Preferred Project Report Modification to Concept Plan

Frasers Broadway
(Formerly CUB Site)

Submitted to
Department of Planning
On Behalf of Frasers Broadway Pty Ltd

October 2008 ■ 08084

Figure 1 – Block 4a Building Height Transition – Abercrombie Street Elevation

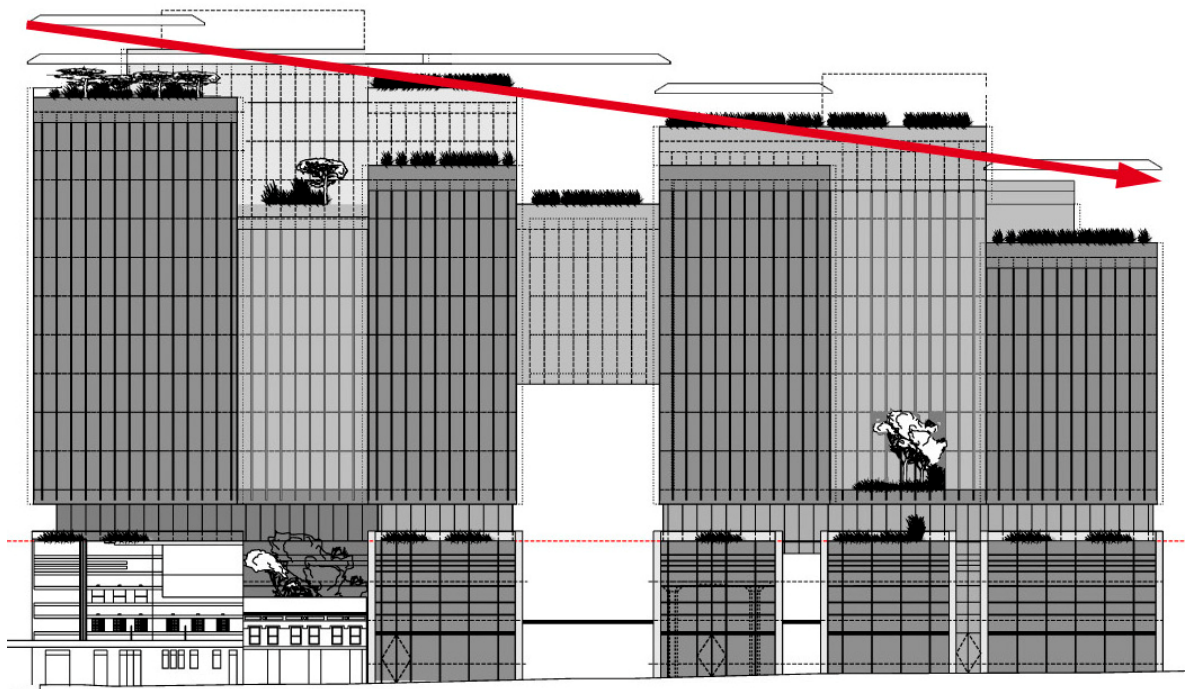
"The massing along Abercrombie Street should be addressed in the context of the surrounding area. This may involve addressing height, bulk, scale and setbacks of the building in this location."

The Building envelope for Blocks 1 + 4a has been revised by Foster + Partners. The revised envelope steps down in height from the corner of Broadway and Abercrombie Streets towards the south, providing a greater transition in building height from Broadway to Chippendale. The overall building envelope has also been broken up to now read as three main building elements connected by linking bridges at the mid to upper levels. Cross sections showing the revised built form of Blocks 1 + 4 are in Plans A-1400 and A-1403 in **Appendix A**. A preliminary elevation showing the building height transition along Abercrombie Street is shown in **Figure 1** below. **Figure 2** shows the proposed massing of Blocks 1 and 4.

Figure 4 – View Tooth Lane eastwards revised design

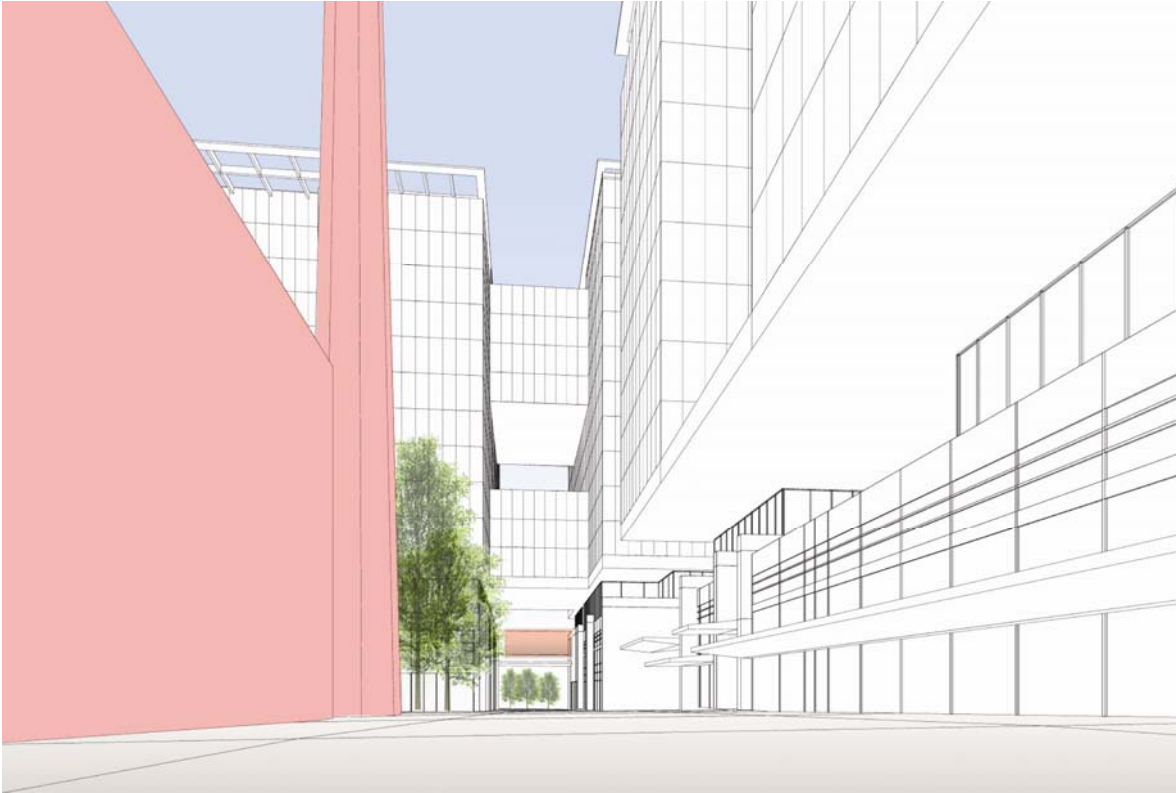
“The pedestrian link to Abercrombie Street from Carlton Street should be amended to improve permeability and vistas between the Brewery Yard / Chimney Stack and the adjoining heritage items (Blackfriars / St Benedict’s Presbytery Church).”

The publicly accessible thoroughways through Blocks 1 + 4 have been widened and increased in height to improve visual and pedestrian connectivity between Abercrombie Street, Broadway and the interior of the site, in particular views and access to and from the heritage Brewery Yard. Revised view perspectives compared with the submitted modification are shown at **Figures 3 to 8**.

Figure 9 – Artist Impression of Block 2a Plates looking east along Tooth Avenue.

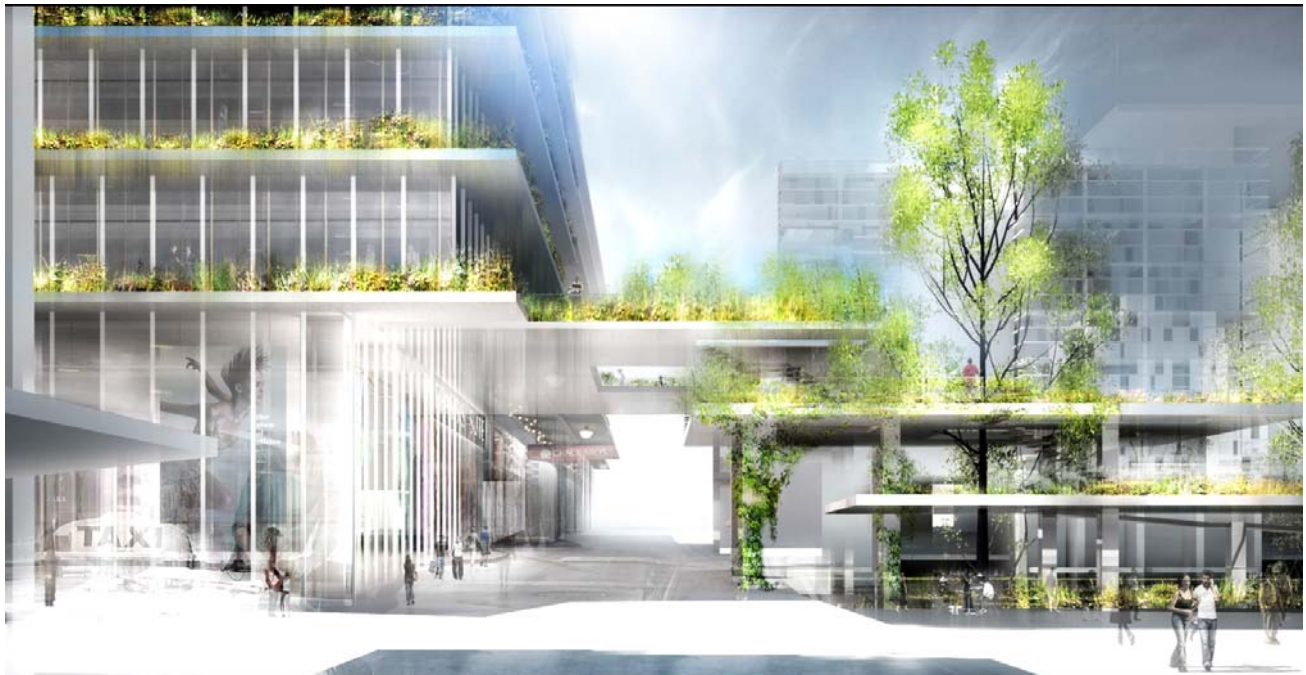
“The project building elements/elevated terraces over Carlton Road [We have assumed the DoP is referring to Tooth Avenue which is immediately south of Block 2 and not Carlton Lane] at the rear (south) of Block 2 detracts from the through views and permeability between Kent Road to Abercrombie Street over this part of the site. These elements should be reconsidered.

The “Green Plates” are an important element in the overall design and function of the site. The plates form a series of landscaped platforms that provide a direct pedestrian link from the public domain over Tooth Lane and up to the podium of Building 2. As shown in **Figures 4** and **9**, the platform over Tooth Lane will be the equivalent of three storeys above the carriage way. The plate will also contain openings above the street to allow light penetration to the area below, further opening up the area visually.

Figure 10 – Block 6 Revisions – Cross Section

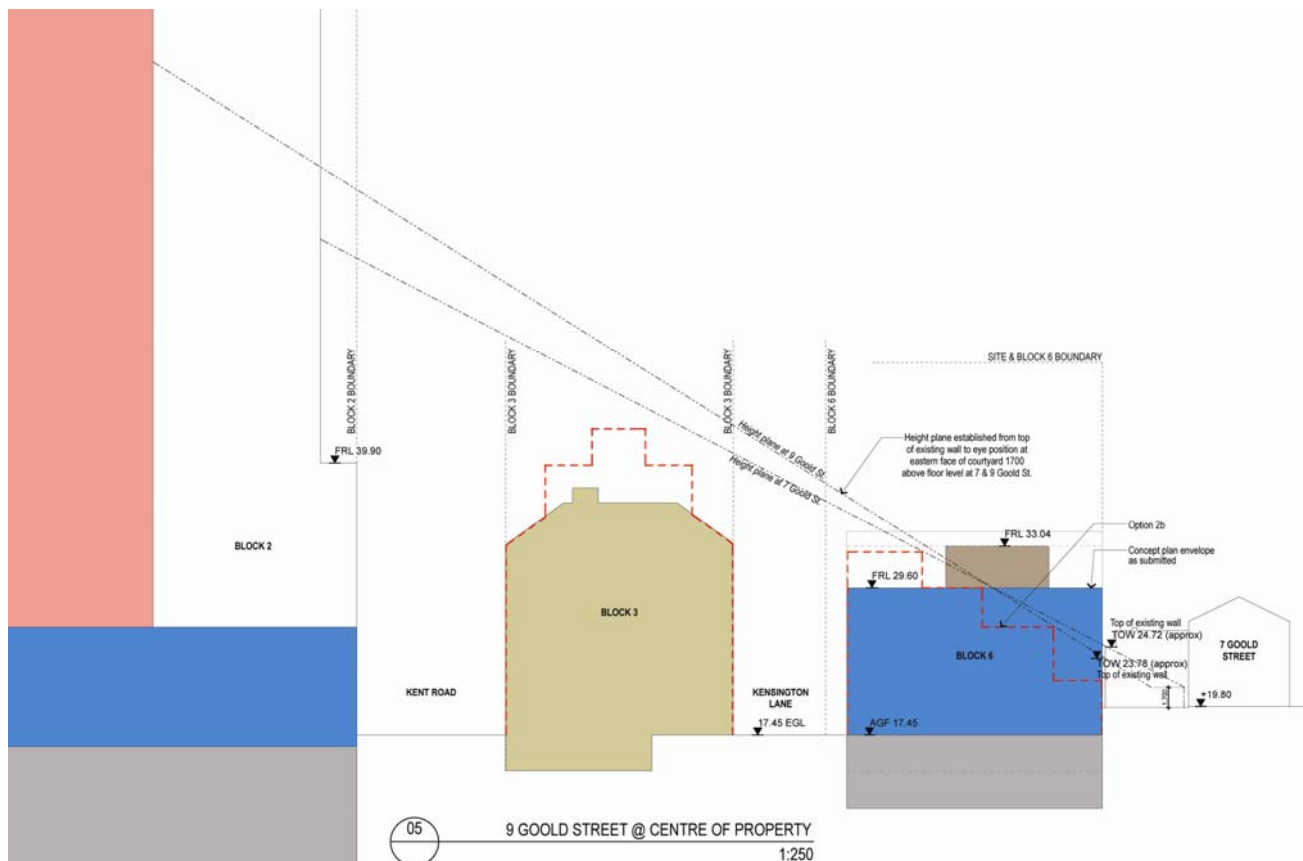
The height, bulk and scale of Block 6 should be reduced to better relate to the pattern of existing bulk/scale of heritage buildings in Kensington Street.

The height and scale of Block 6 is considered to be consistent with the surrounding built form context. Similar or higher building forms adjoin the site to the west across Kensington Street (Block 3) and to the rear on Dwyer Street. Notwithstanding this, the rear of the Block 6 building has been amended to step back from the existing 2 storey dwellings in Goold Street to maintain the height plane from the rear of the dwellings to the existing structures on the site. A cross section showing the relationship of the proposed Block 6 envelope with properties at the rear on Goold Street is shown in **Figures 10 and 11**.

Figure 12 – Proposed (green) and approved (red) massing on the site viewed from north east.

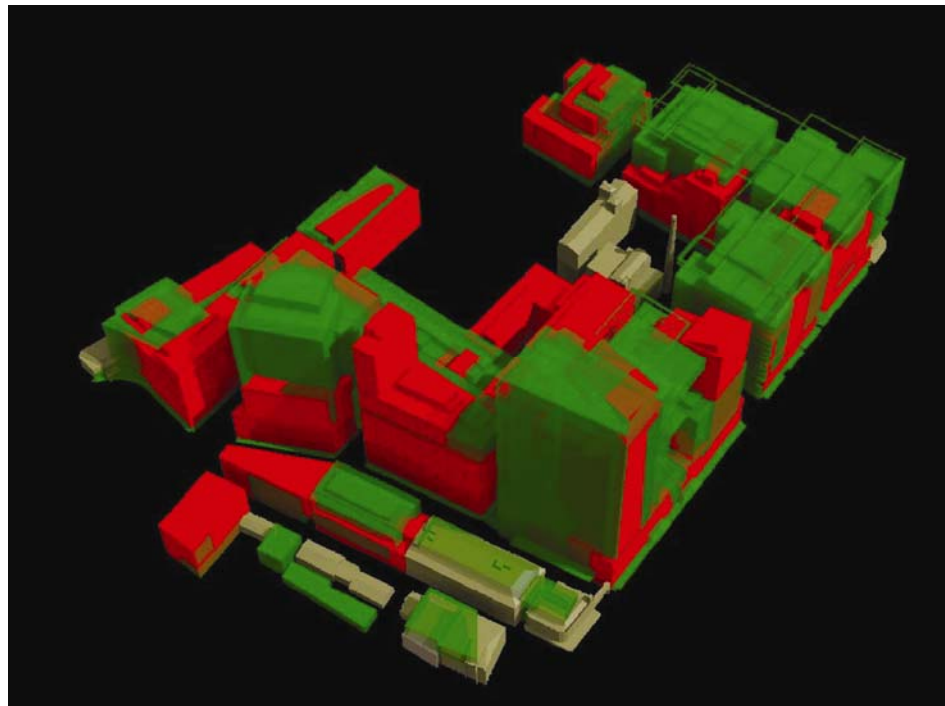
"A full set of scaled (minimum A3 size) elevations and section plans of the approval (including height plane) overlaid by the proposed modification (using colour differentiation)."

Plan A-2010 shows a 3-D representation of the changes to massing on the site. **Figures 12 and 13** below show the proposed massing (green) and approved (red) for the site when viewed from the north-east and south-west.
